1084S-P MONITOR REPAIR KIT
314891-01
MAY 1988

1084S-P MONITOR REPAIR KIT - CBM PART NUMBER 314891-01

1084S-P MONITORS, PRODUCED BY PHILIPS BETWEEN JUNE 1988 AND SEPTEMBER 1988, HAVE EXHIBITED A LOSS OF HIGH VOLTAGE DUE TO THE FAILURE OF THE LINE OUTPUT TRANSFORMER (LOT), T402. AS A RESULT OF THE FAILURE OF T402, RESISTOR R475 (15K, 2W) AND CAPACITOR C476 (.047uF) HAVE OPENED.

COMPONENT SIDE

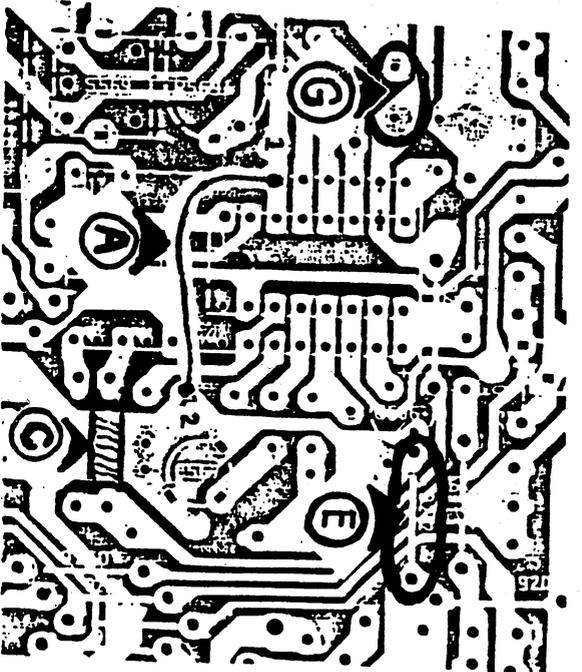
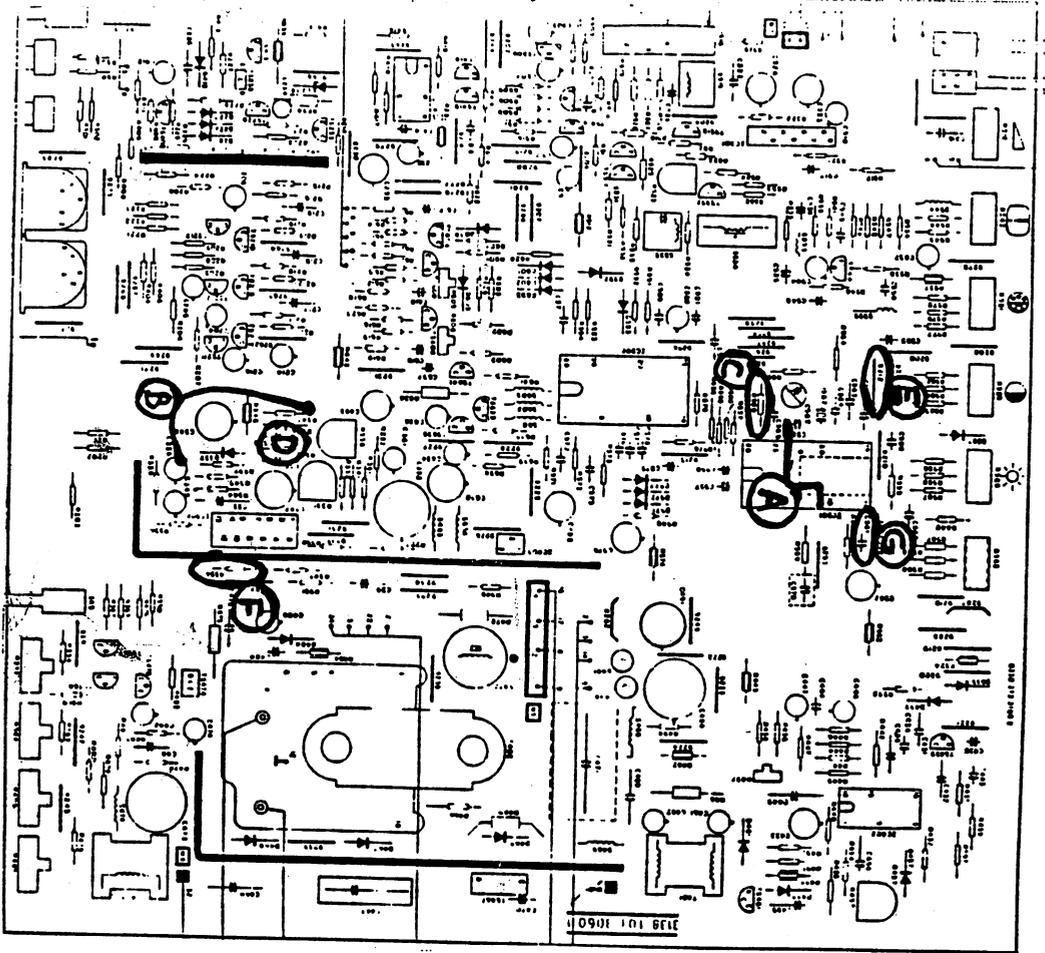
THE FOLLOWING FIX IS FOR UNITS MANUFACTURED BETWEEN JUNE 1988 AND SEPTEMBER 1988 WHICH EXHIBIT "FLASHING" SYMPTOMS.

REFER TO DIAGRAMS ON PAGE 4 (REVERSE SIDE). NOTE JUMPERS AND CUTS SHOULD BE MADE TO SOLDER SIDE OF THE PCB.

- A) USING ORANGE JUMPER WIRE PROVIDED IN KIT, CUT A ONE (1) INCH LENGTH AND SOLDER BETWEEN POINTS 1 AND 2 AS SHOWN ON SOLDER SIDE DIAGRAM. THESE POINTS ARE FROM PIN 3 OF IC501 TO C569.
- B) USING ORANGE JUMPER WIRE PROVIDED IN KIT, CUT A TWO (2) INCH LENGTH AND SOLDER BETWEEN POINTS 3 AND 4 AS SHOWN ON SOLDER SIDE DIAGRAM. THESE POINTS ARE FROM R347 TO *Negative* SIDE OF C334.
- C) CUT AWAY COPPER FOIL, AS INDICATED BY SLANTED LINES ON SOLDER SIDE DIAGRAM.
- D) CUT AWAY COPPER FOIL, AS INDICATED BY SLANTED LINES ON SOLDER SIDE DIAGRAM.
- E) REMOVE JUMPER 9212.
- F) REMOVE CAPACITOR C356, AND REPLACE WITH .0056uF CAPACITOR INCLUDED IN KIT.
- G) ADD CAPACITOR C561, .022uF, IF NOT ALREADY ON PCB.
